# IEEE P802.3bt PSE State Diagram Comments

Dan Dove, DNS for LTC

*November 6, 2015*

# Objectives of this Presentation:

Figure 33-9a—Type 3 and Type 4 top level PSE state diagram

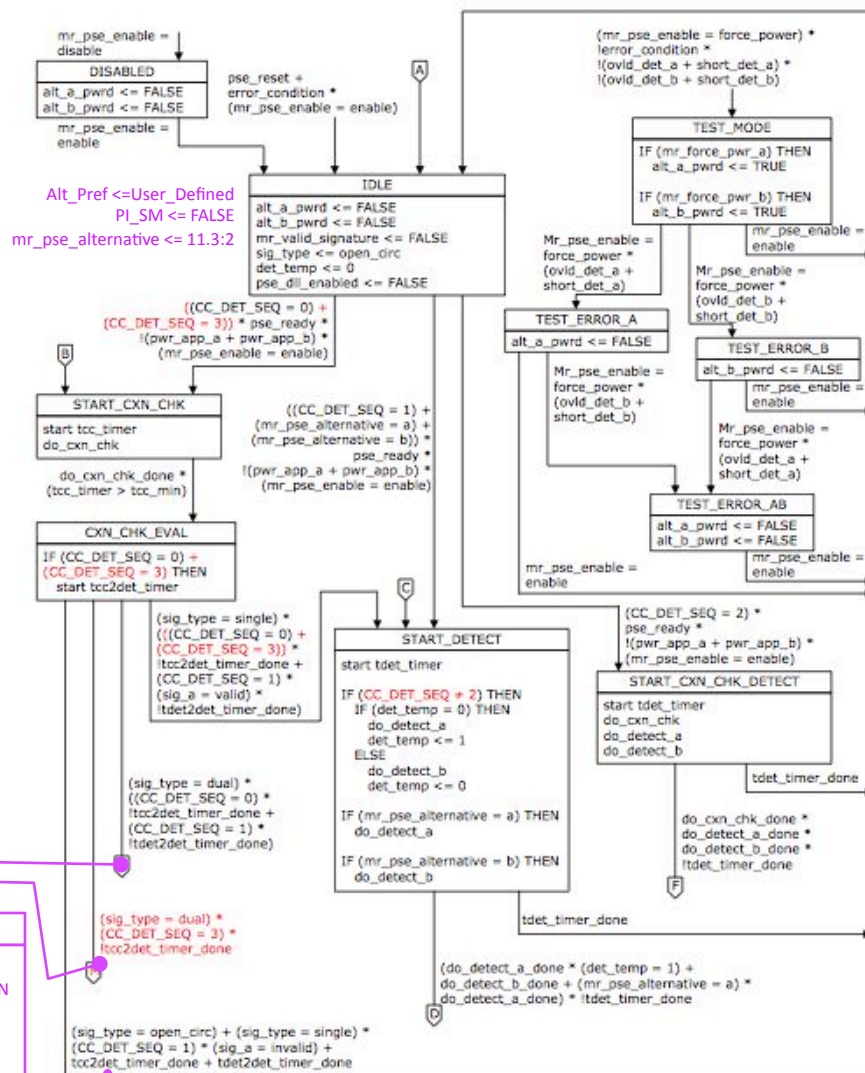
The E and M arcs go to multiple locations. To fix this, we create a state that sets flags telling those sub-state-machines to start up.

- PI\_SM: Flag that tells PI\_State Machines to start
- StagDet: Tells PI\_State Machines whether to run detection sequentially (staggered) or simultaneously.

When both sub-state-machines are done, they set flags to cause the PI\_SM\_START exit arc to be TRUE.

Alt\_Done\_A: Says alt\_a detection is stopped  
Alt\_Done\_B: Says alt\_b detection is stopped

Additional variable initialization in IDLE state.

Note: This state is only drawn here for ease of comment. Final drawing would integrate the additional state cleanly.

### Dual Path State Machine Discussion: (continued)

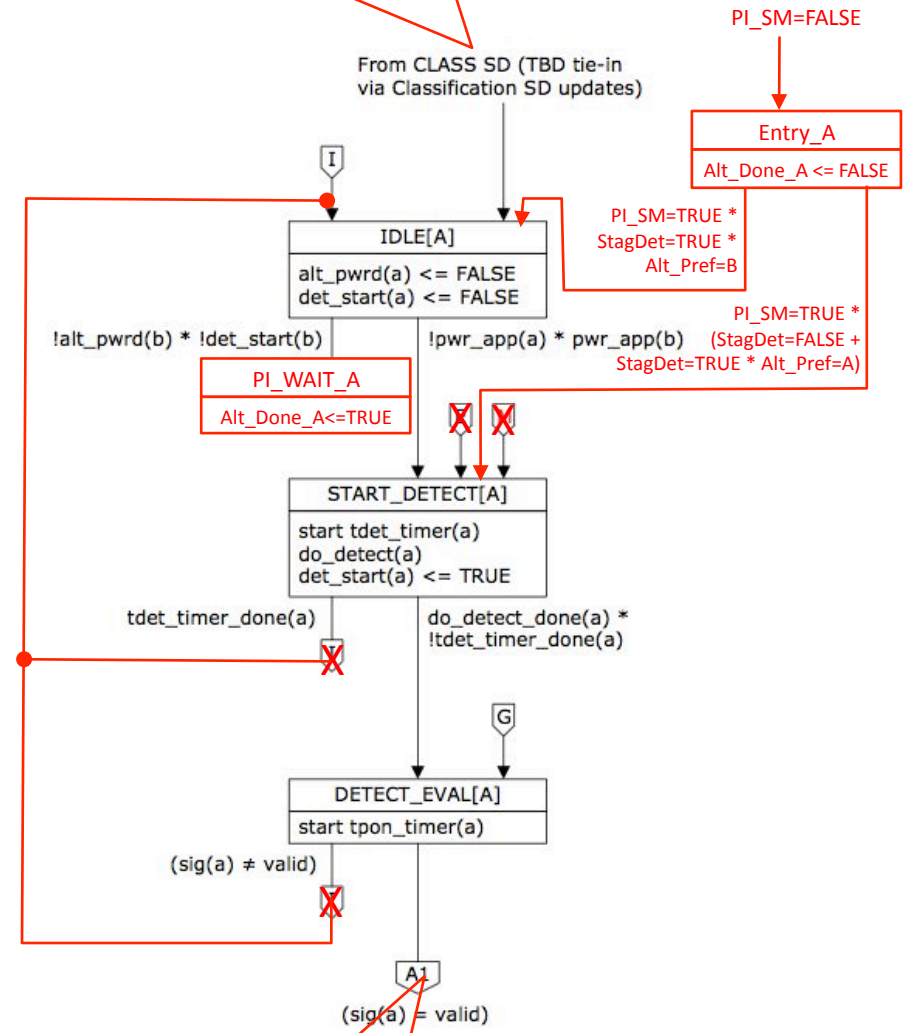
Create an Entry\_A state that is entered whenever PI\_SM is FALSE. (Initialized by IDLE in upper state machine)

Exit from this state is controlled by PI\_SM=TRUE which occurs when the upper state machine enters the PI\_SM\_START state.

Direction to either IDLE\_A or START\_DETECT\_A is based on whether StagDet is TRUE, and if so, whether the Alt\_Pref is A or B.

For the case where StagDet is FALSE, both alt\_a and alt\_b detections will occur immediately.

For the case where StagDet is TRUE, Alt\_Pref will decide which alt goes to IDLE and which one goes to START\_DETECT.

Eliminated the intrapage connectors for cleanliness.

When in IDLE[A] and the other alt is in IDLE[B], both alts drop into the PI\_Wait\_A/B states, set the Alt\_Done\_A/B flags. This triggers the upper level state machine to return to IDLE.

Arc M and Arc E entries are no longer required.

This will have to change. A CLASS[a] State Diagram required

### Dual Path State Machine Discussion: (continued)

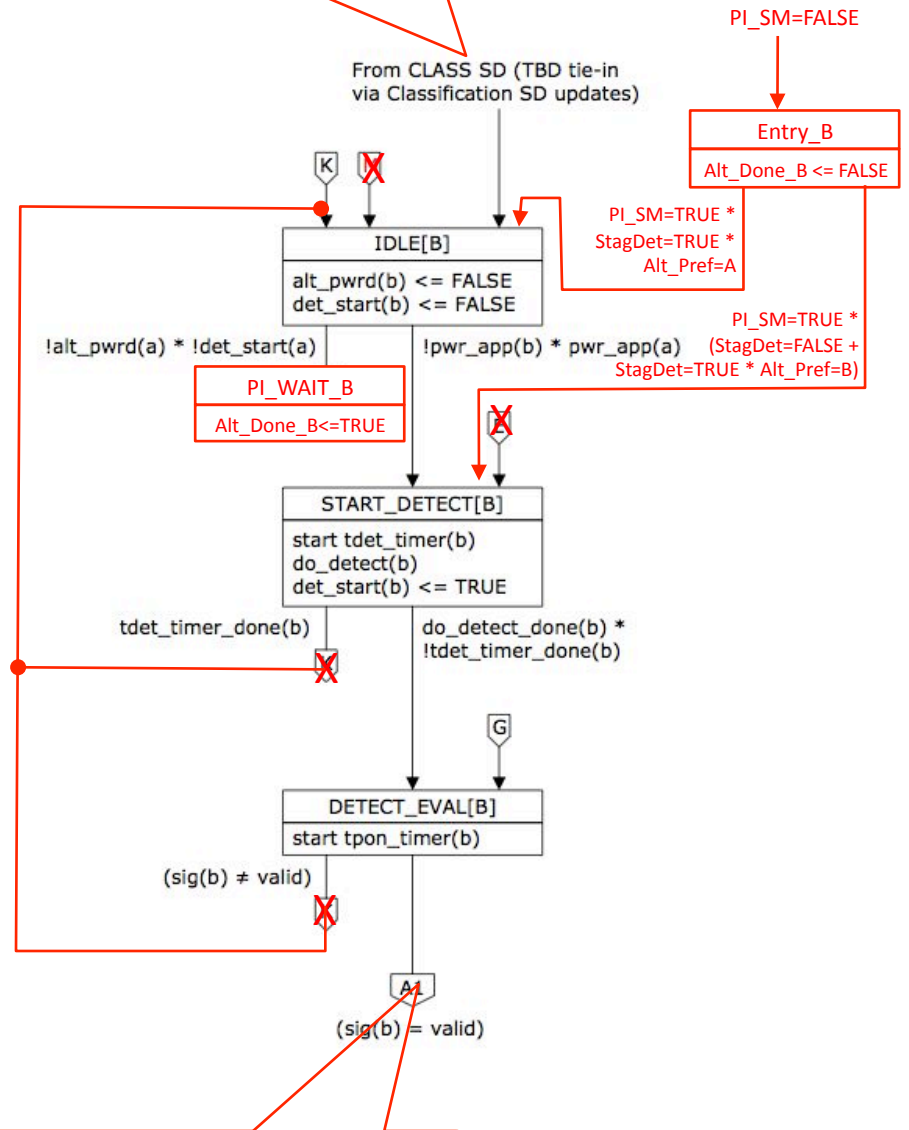
Create an Entry\_B state that is entered whenever PI\_SM is FALSE. (Initialized by IDLE in upper state machine)

Exit from this state is controlled by PI\_SM=TRUE  
 Direction to either IDLE or START\_DETECT is based on whether StagDet is TRUE, and if so, whether the Alt\_Pref is A or B.

For the case where StagDet is FALSE, both alt\_a and alt\_b detections will occur immediately.  
 For the case where StagDet is TRUE, Alt\_Pref will decide which alt goes to IDLE and which one goes to START\_DETECT.

Eliminated the intrapage connectors for cleanliness.

When in IDLE[B] and the other alt is in IDLE[A], both alts drop into the PI\_Wait\_A/B states, set the Alt\_Done\_A/B flags. This triggers the upper level state machine to return to IDLE.

Arc M and Arc E entries are no longer required.

This will have to change. A CLASS[b] State Diagram required

## CLASS EVAL[A] Page Discussion:

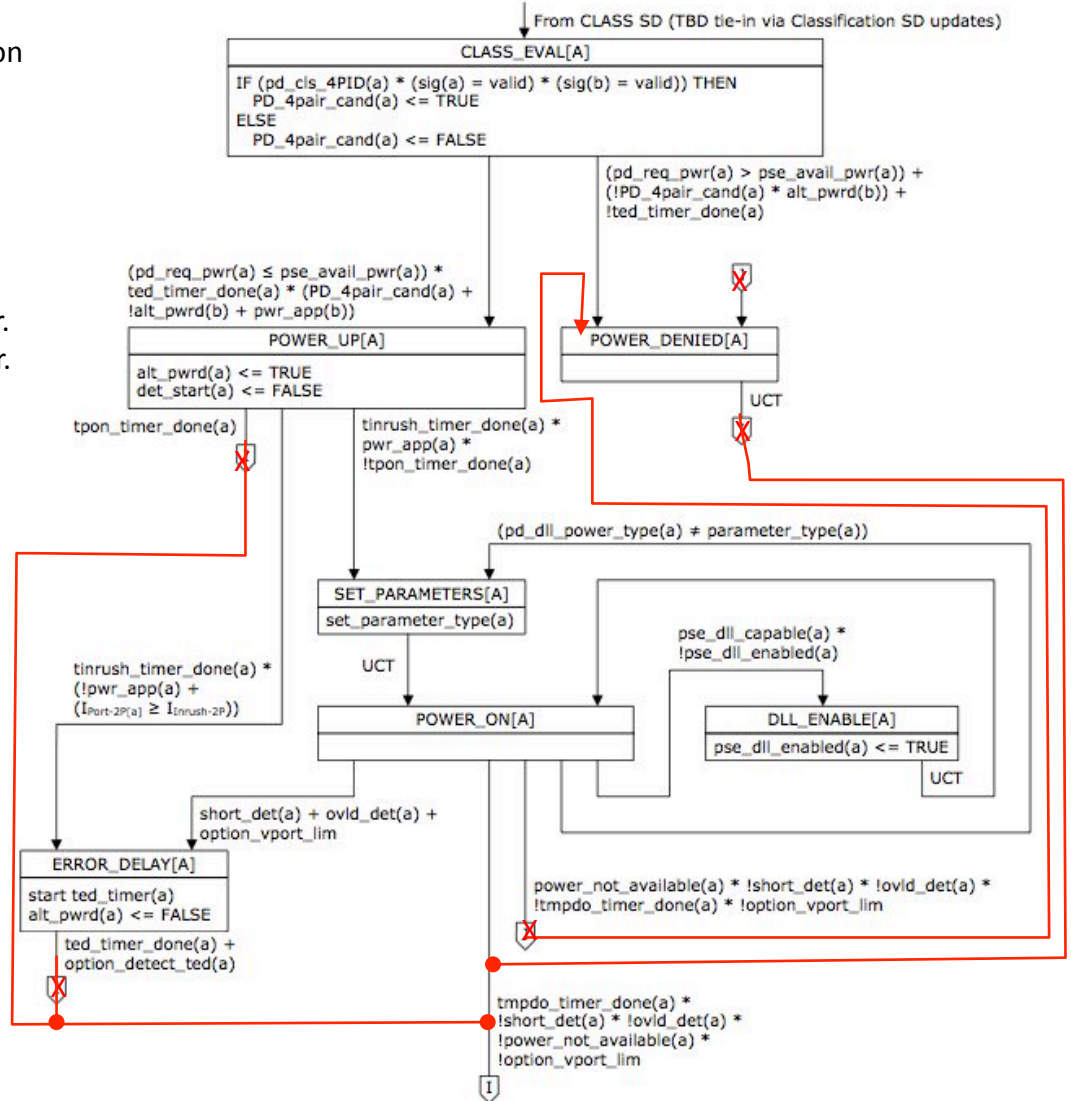
Its expected that the entry point into this page will be from a new CLASS[a] page that addresses how to perform classification on the alt\_a pairset while alt\_b is either awaiting detection, in detection, or in its own classification and/or power\_on state processes.

There is not much to this page to recommend other than getting rid of the intrapage connectors.

Note: For the J path, I would move POWER\_DENIED[A] over to the right a bit to clean & clear the pathway better. Also, move the arc from CLASS\_EVAL[A] to make it neater.

This will have to change. A CLASS[a] State Diagram required

Figure 33-9a—Type 3 and Type 4 top level PSE state diagram (continued)

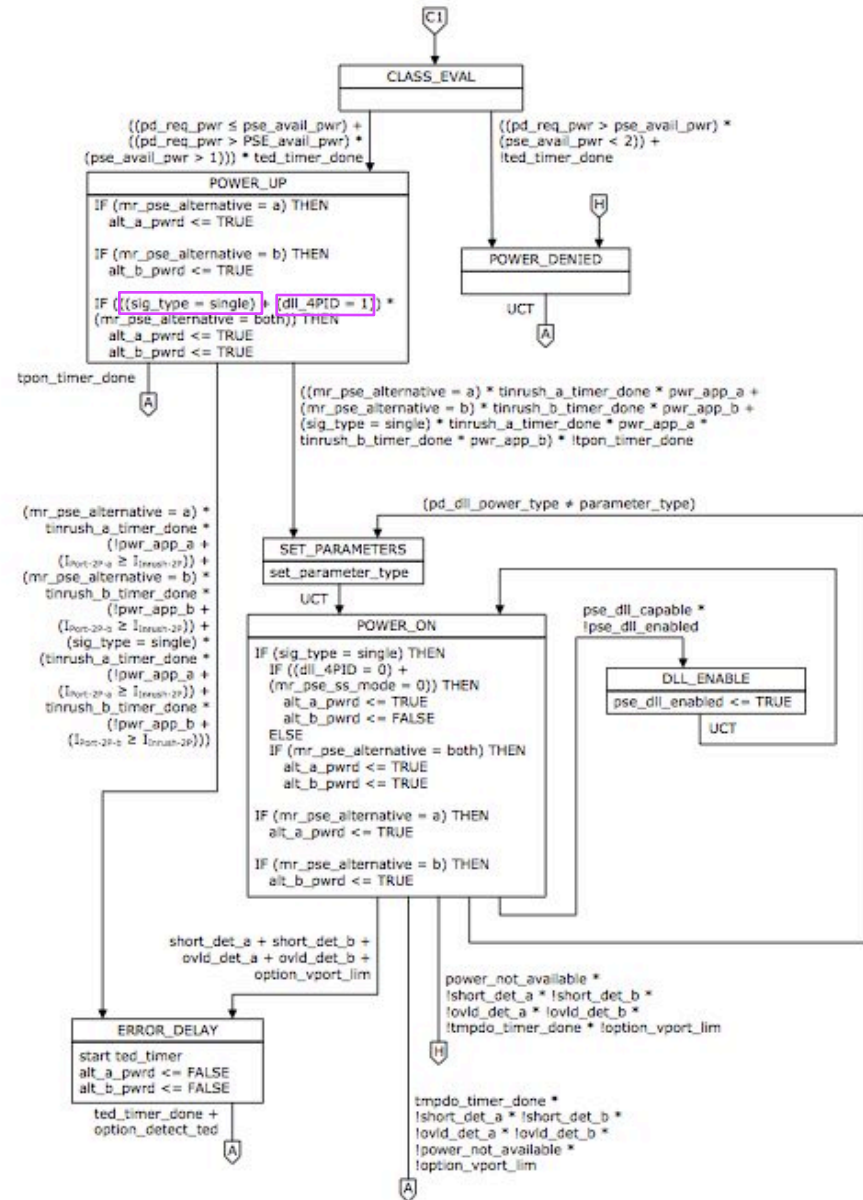
Logic term “sig\_type=single should not exist in this diagram. For cases where sig\_type=dual, would be in the other alt\_a / alt\_b state diagram paths.

In POWER\_UP, dll\_4PID=1 term is not possible since pse\_dll\_enable has not yet been set to TRUE.

If ANY logical condition was added, perhaps

This is nice because it allows the PSE “ubiquitous management” to decide that it does NOT want to power up all 4 pairs even though the PSE is configured to power 4 pairs via the mr\_pse\_alternative variable.

\*Note: We may need to initialize mr\_ss\_pse\_mode in IDLE or another state to ensure it does not change values between states.

IF mr_pse_alternative = both * mr_pse_ss_mode = 1
THEN
    alt_a_powered <= TRUE
    alt_b_powered <= TRUE
ELSE
    alt_a_powered <= TRUE
    alt_b_powered <= FALSE

Figure 33-9a—Type 3 and Type 4 top level PSE state diagram (continued)

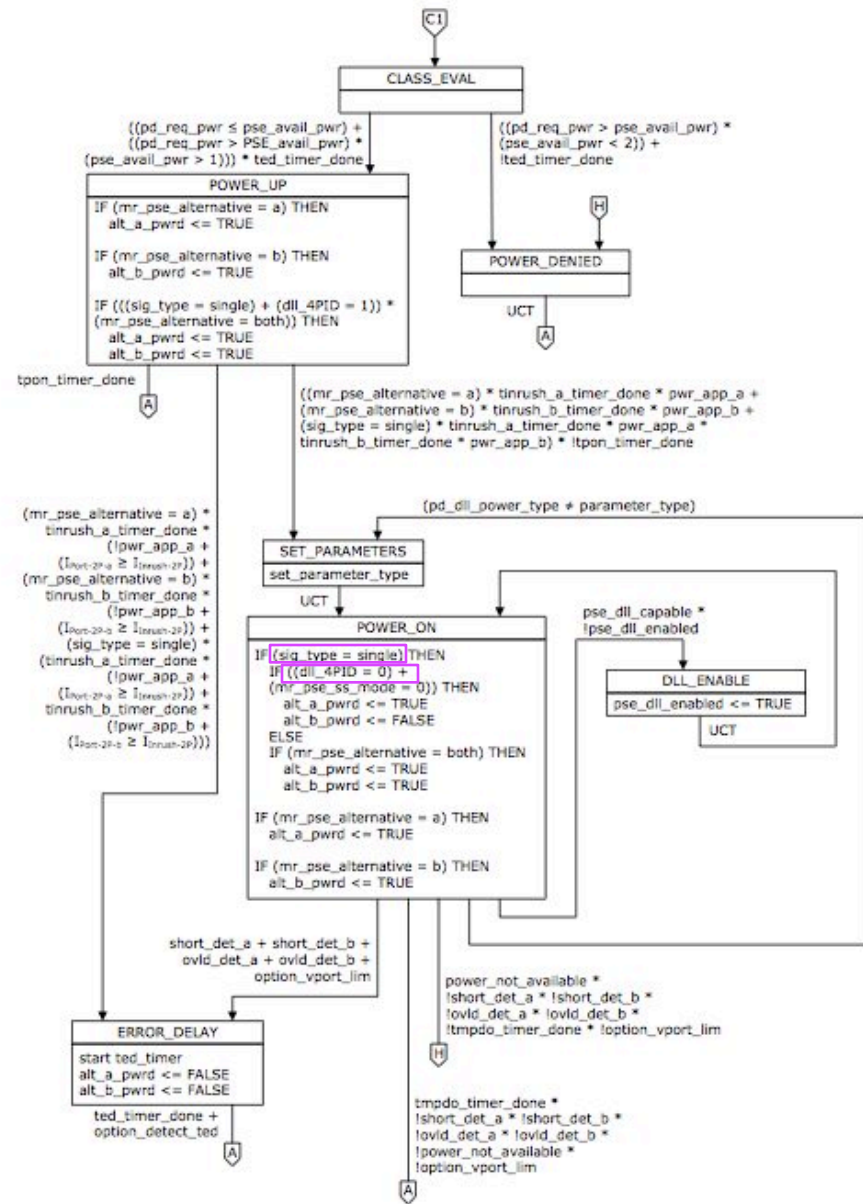
Logic term “sig\_type=single should not exist in this diagram either. For cases where sig\_type=dual, would be in the other alt\_a / alt\_b state diagram paths.

In POWER\_ON, dll\_4PID=0 term, and the logic with mr\_pse\_ss\_mode = 0 would ALWAYS be TRUE on entry into this state. So a PSE that powered up both pair-sets, would be required to immediately un-power a pairset [B] upon entry. This makes no sense and is an odd behavior.

I believe the goal should be smooth operation with the ability to turn OFF a pairset due to DLL intervention, not to power it up, turn it off, then turn it back on with DLL intervention only.

Replace first logic block with:

IF (mr_pse_alternative = both) THEN
  IF ((dll_4PID = 1) + mr_pse_ss_mode = 1)) THEN
    alt_a_pwr <= TRUE
    alt_b_pwr <= TRUE
  ELSE
    alt_a_pwr <= TRUE
    alt_b_pwr <= FALSE

This logic would allow all 4-pair PSEs with mr\_pse\_ss\_mode=1 maintain power on all 4 pairs. They would only drop power to alt\_b if dll\_4PID remains 0 and mr\_pse\_ss\_mode is set to 0. Ubiquitous mgmt, upon receiving dll\_4PID=0, could clear mr\_pse\_ss\_mode to 0 if they wish to power down alt\_b.
